**ADDENDUM NO. 3**

**TO:** ALL RESPONDING PARTIES TO THE BID FOR THE  
**NEW COMMUNITY GARDEN INSTALLATION PROJECT**

**SUBJECT:** Bid Clarifications

**Project:** 18037 MH Community Garden

Scale: NTS	Revision Date: 11/26/2018	Sketch #: SK-2	Drawing Revision to Sheet: 9/A2.2
------------	---------------------------	----------------	-----------------------------------

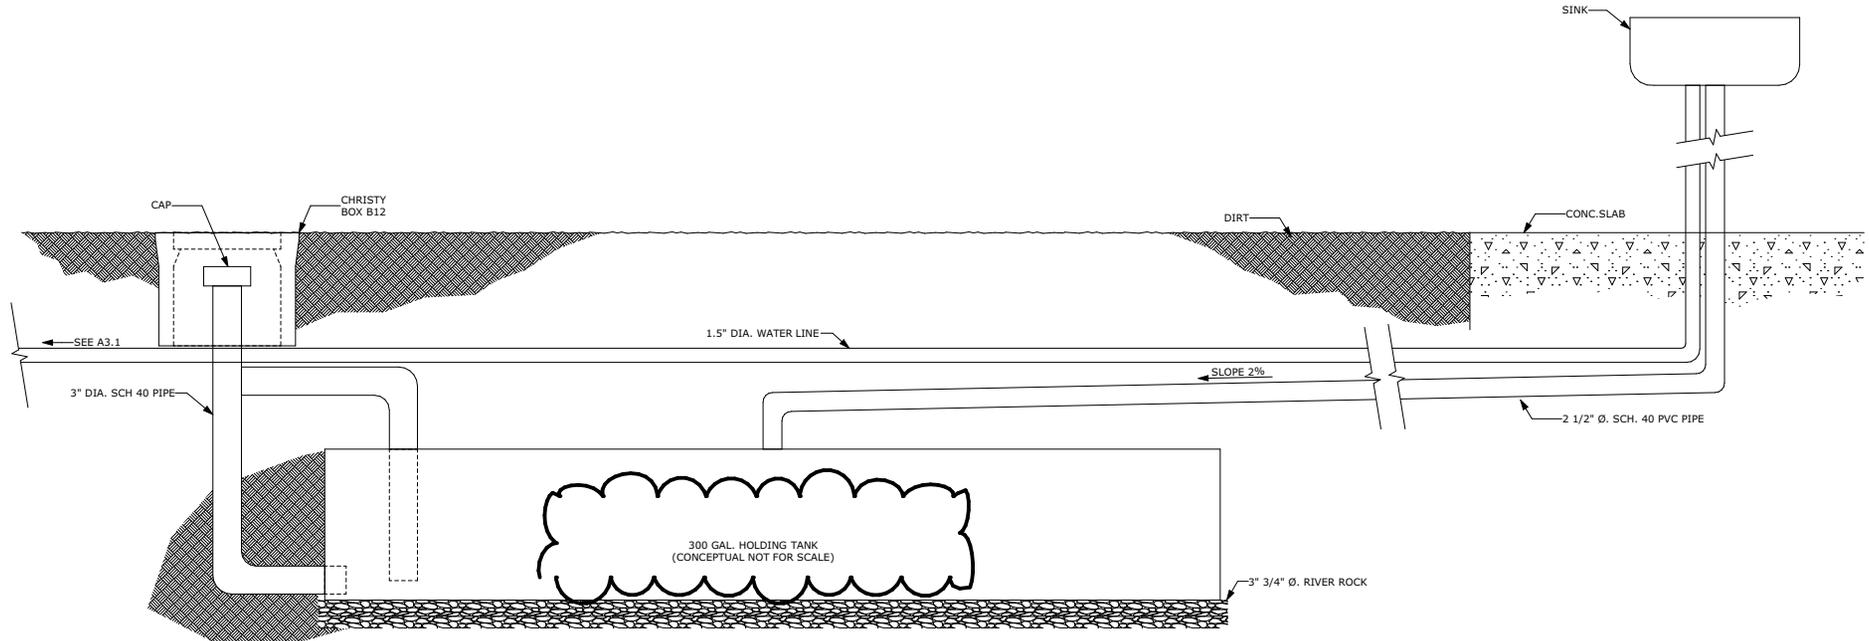
2. A2.2 (See SK-2) - Revised size of water tank to 300 gallons
- IX. PRE-BID RFI RESPONSES:
1. Confirm all aggregate base sections are 4" thick.  
**A: Yes, all aggregate base sections are 4" thick.**

Description: CHANGE WATER TANK SIZE TO 300 GALLONS
